The City of Spartanburg Board of Architectural Design & Historic Review

AGENDA

January 11, 2024, at 5:30 P.M.

RE: Certificate of Appropriateness for Major Works – 266 Hydrick Street (TMS: 712-14-172.00) in the Hampton Heights Neighborhood Historic District. The applicant is seeking approval of the **new construction of a single-family structure on a vacant lot**. The property is located in the R-8 SFD (General Residential – Single Family District). Owner/Applicant: Royce Camp, Royce Camp Construction, LLC.

266 Hydrick ST
SITE PLAN

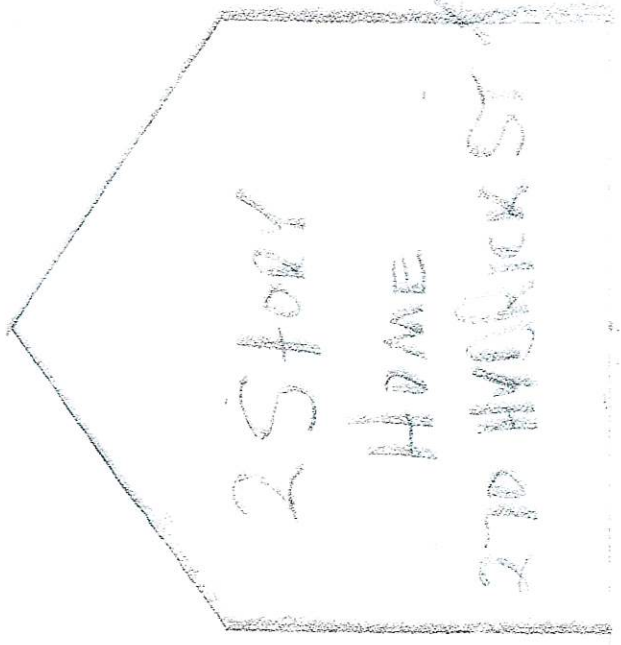
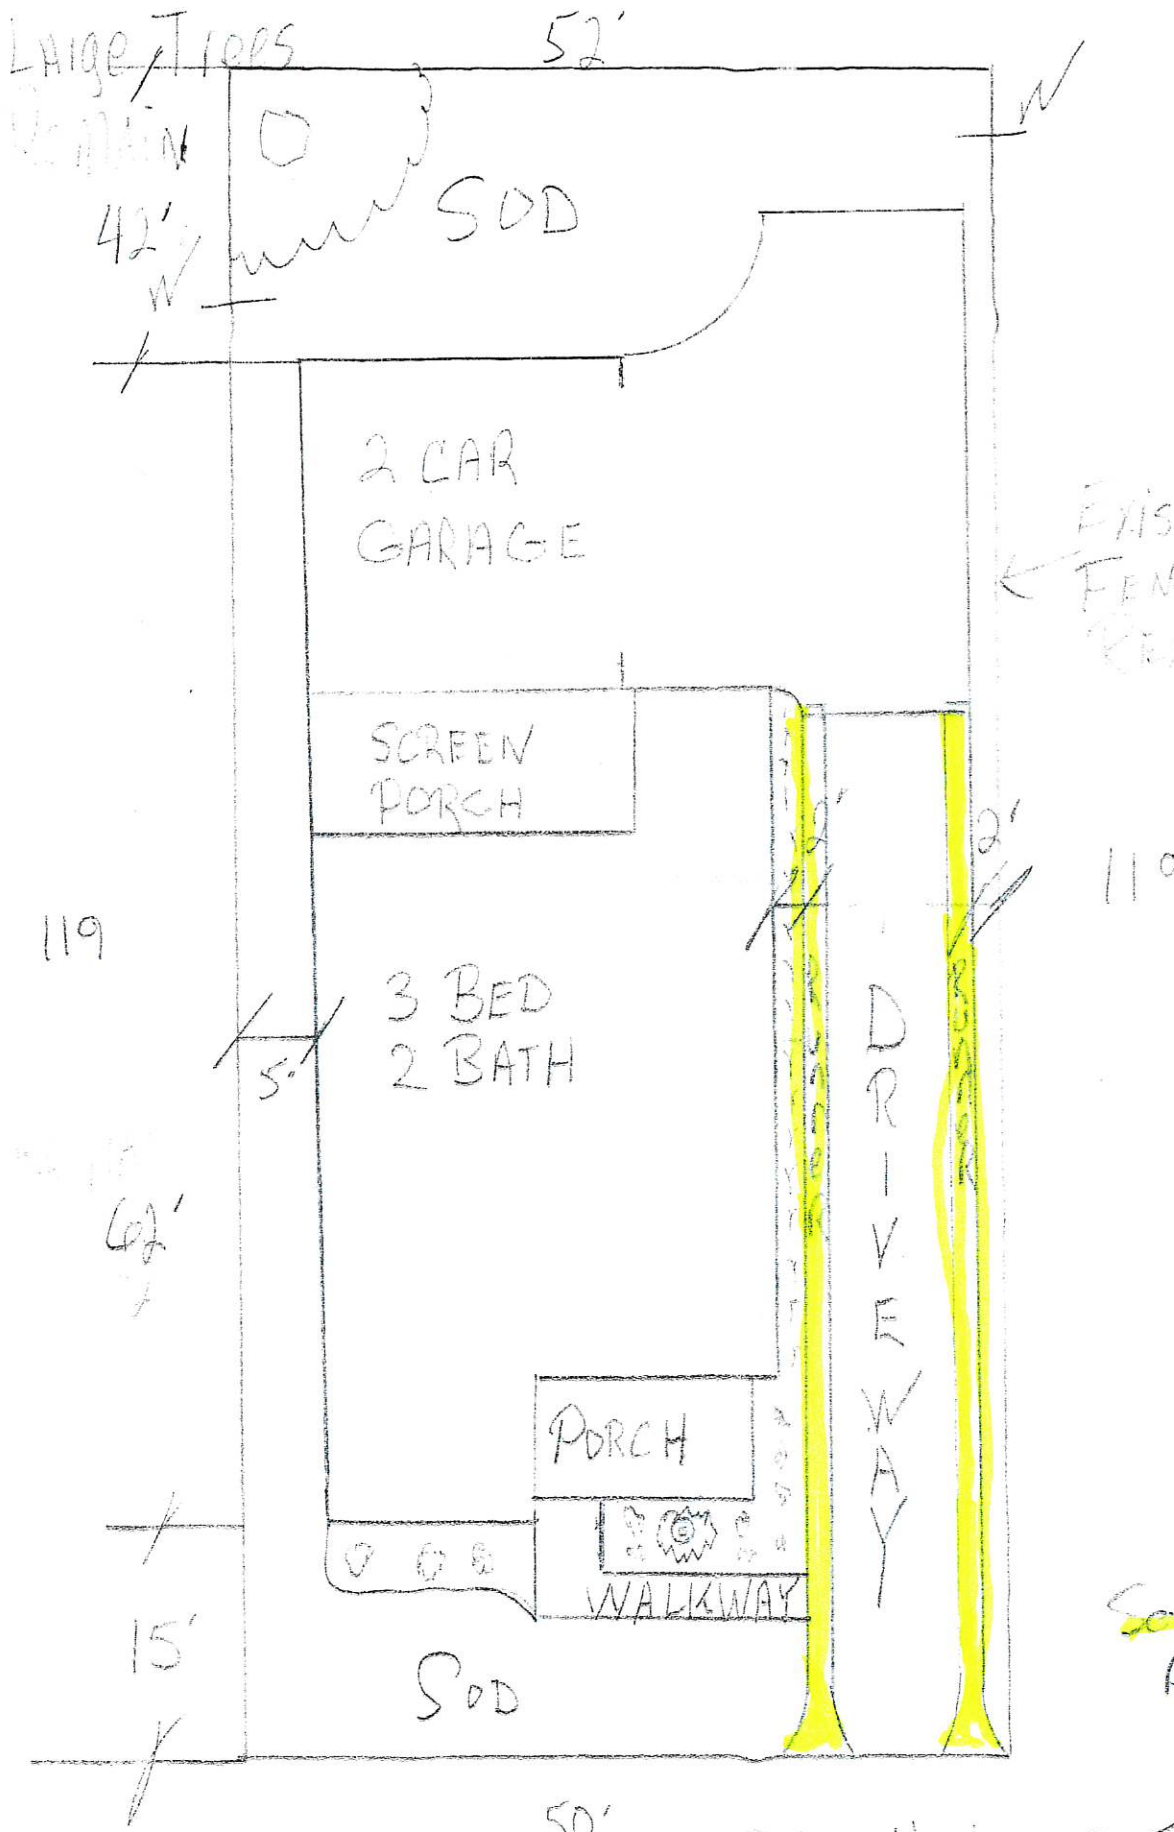
6.2.1 Building Setback and Orientation: • The orientation of a new building and its site placement shall appear to be consistent with dominant patterns within the area of influence, if such patterns are apparent. The orientation and setbacks of the proposed house will match those of the surrounding houses. The house shall be required to meet the R-8/SFD district standards which stipulates that the front setback shall be 30 feet and the side setbacks shall be eight feet. The 30-foot setback requirement does not appear to be similar to the other surrounding properties on the street. The applicant may be required to apply for Variance before the Board of Zoning Appeals to allow the home constructed to be similarly placed on the lot as other homes on the street. Furthermore, the side setback extends beyond the required 8-foot interior side setback by 3 feet, but will be approximately 10 feet from 270 Hydrick St.

6.2.3 Shape: • Roof Pitch: The roof pitch of a new building shall be consistent with those of existing buildings within the Area of Influence, if dominant patterns are apparent. Staff needs additional details regarding the roof pitch. At this time the owners states that the Above Finished Floor height will be 24 ft.

The proposed scale of the new structure will match adjacent residential properties. The adjoining property is two-story, whereas this home will be a single story structure. However, the remaining properties appear to be single story homes. All of the lots have the same measurements, including the front width of each lot. Right now the building's footprint exceeds the setbacks for the R-8 SFD of Hampton Heights, which is below. The proposed layout sits 5 ft from the property line on the south, which allows for a striped driveway on the north. The owner states that the front porch will be aligned with the neighboring property. Planning Staff did advise Mr. Camp that he may be required to apply for a zoning Variance to allow for the structure to be built beyond the setback.

Location for proposed shed

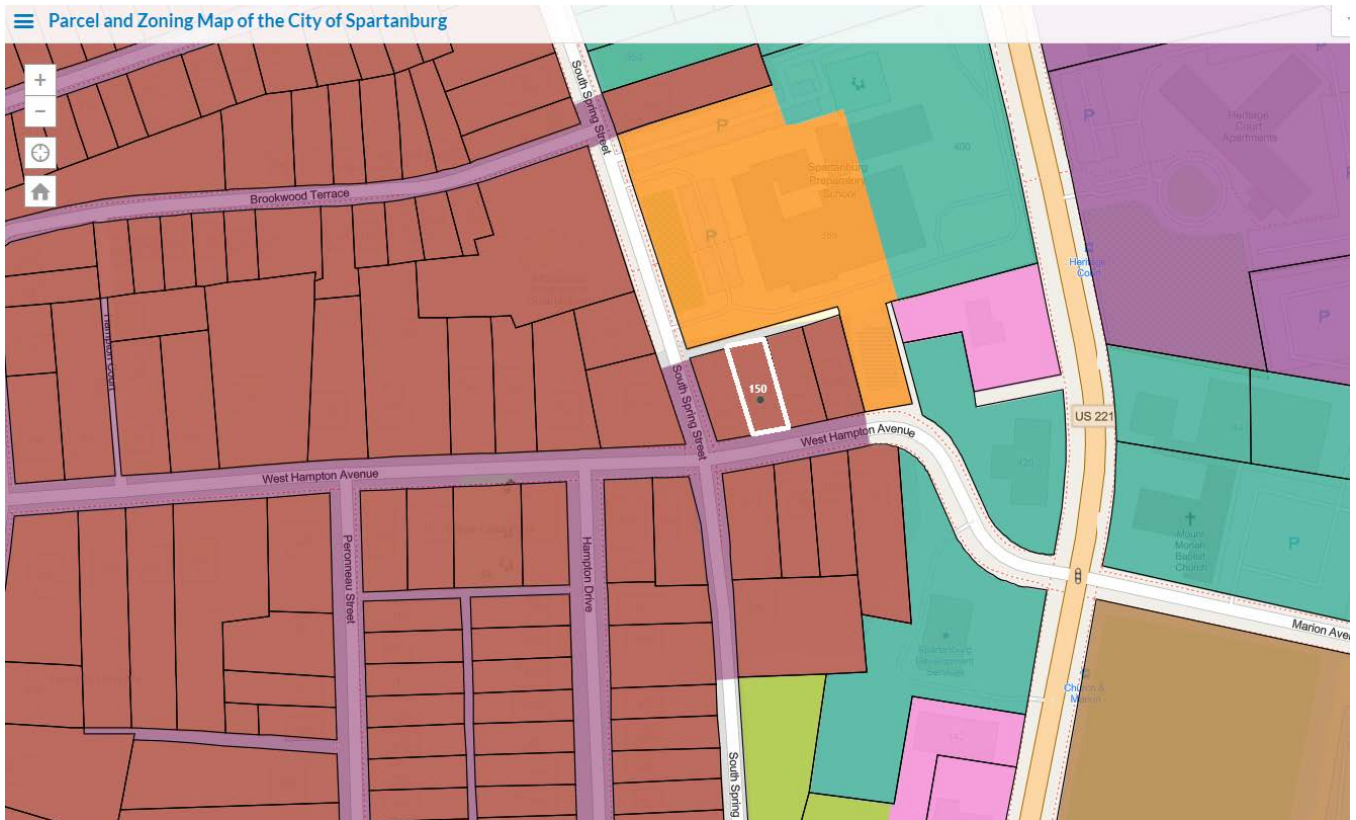
Applicant /Owner would like to place a prefabricated shed in the rear of his property. The shed is a size 10' x 12', and being under 200sf, the structure does not require a permit from the Building Department. The proposed location makes the shed partially visible from the sidewalk while standing in front of the driveway. The applicant plans to follow the zoning code regarding placement of the shed; per the City of Spartanburg Zoning Code **§501.4 Accessory Buildings in Residential Districts**, *accessory buildings shall be located not less than five (5) feet from any side or rear lot line.*

The applicant has chosen a prefabricated shed from a local retailer. The size is 10ft x 12ft with a maximum height of 7ft at the roof's peak. The shed will be wrapped in vertical siding. The owner has chosen the shed with a single door entrance and a small window in the front. The owner plans to position the shed along the same property line as the driveway (behind the 6ft gate), so the door to the shed is facing west. The side of the shed will be seen from the sidewalk, specifically the top portion / roof view.
